## Comment on Applicant response to ExQ1 Q1.3.5 (Timeline)

## Comment on Applicant response to ExQ1 Q1.4.2 (Single Axis Tracker)

## Appendix. The Need for Overplanted SAT (Author Analysis)

## Comment on Applicant response to ExQ1 Q1.5.1a (Power)

Figure 6-6 is even more baffling.

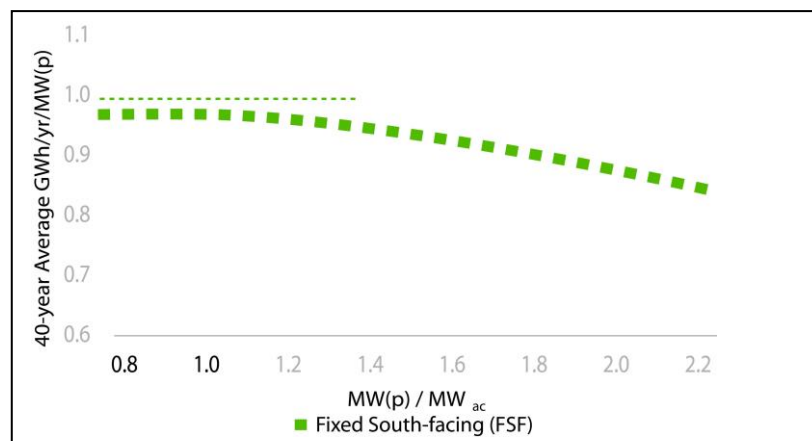
One would expect a plot of energy-per-panel against overplanting ratio to be horizontal to the left of MW(p)/MW<sub>ac</sub>=1.0 (dashed green line, right), rather than drooping off.

What is the explanation for the droop?

Again, the reader is invited to perceive an ‘inflection point’ in the curve, this time at around ratio = 1.3 (Author Analysis). There is simply nothing to see there. Bizarrely, there is a hint of ‘kink’ at around 1.5 for the SAT curve, but without authentication of the “inputs,” nothing consequential can be inferred from either this or the previous graph.

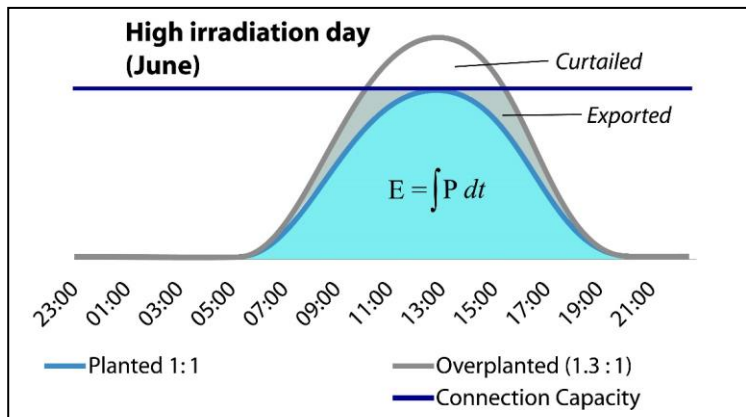
Although panel output is indeed affected by degradation (and soiling, high temperature, etc), overplanting is conventionally justified solely on financial grounds.

At 30% overplanting, some of the panel energy on a high-irradiation day will be discarded ('curtailed,' see figure). However, the exported energy will still exceed that of a unity-planted scheme (blue). At lower irradiance (e.g. left panel in Fig 6-4), all the additional energy from overplanted panels is exported.

In determining the optimum overplanting ratio, long-term additional financial yield is weighed against the additional up-front cost (panels and land). With excess overplanting, curtailment predominates. Other parameters, such as maximum inverter input voltage, must be considered at the design phase.

It is certainly true that degradation will contribute to the calculation of long-term yield, but overplanting is not (for most solar designers) a technique to overcome the consequences of panel ageing. It pays dividends, literally, from day one.

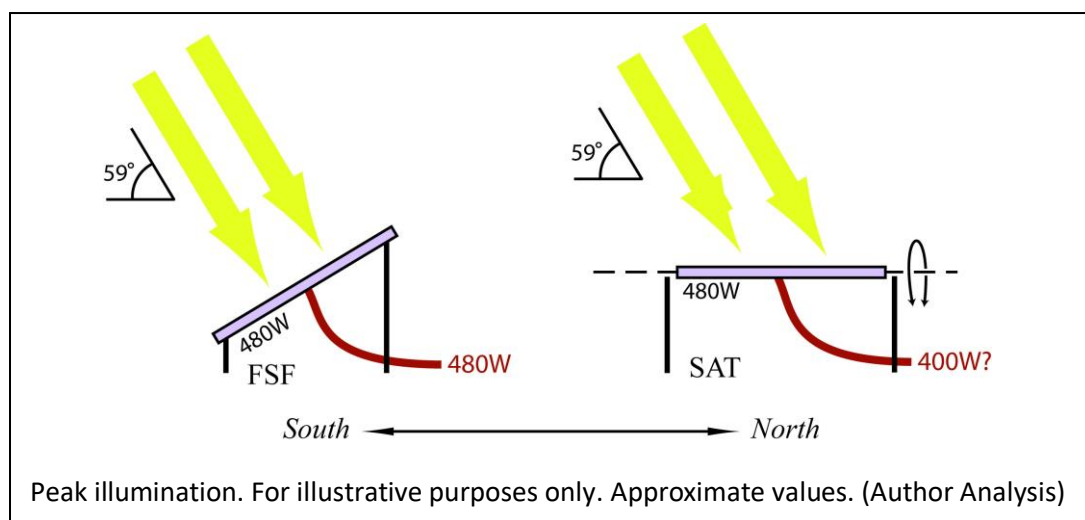
With trackers (SAT), unlike fixed panels (FSF), the incoming light never achieves normal incidence (90°).

At maximum sun elevation (59°), the SAT incidence angle will be 31° (90° – 59° = 31°). Assuming a  $\cos \theta$  solar incidence relationship (for a first approximation), 411 MW DC will be produced by a 480 MW SAT array:  $480 \cos(31^\circ) = 411$ .<sup>1</sup>

If the Scheme aims to export 400 MW with 1.3:1 overplanting<sup>2</sup> and (optimistically) total overall losses of 5%, then they should be working with a target SAT Installed Capacity of 638 MW at this stage of the design process, not 480 MW.

$$638 \cos(31) \times \frac{1}{1.3} \times 95\% = 400$$

What equation is BOOM using?

Further clarification must be sought for the 480 MW Installed Capacity figure.
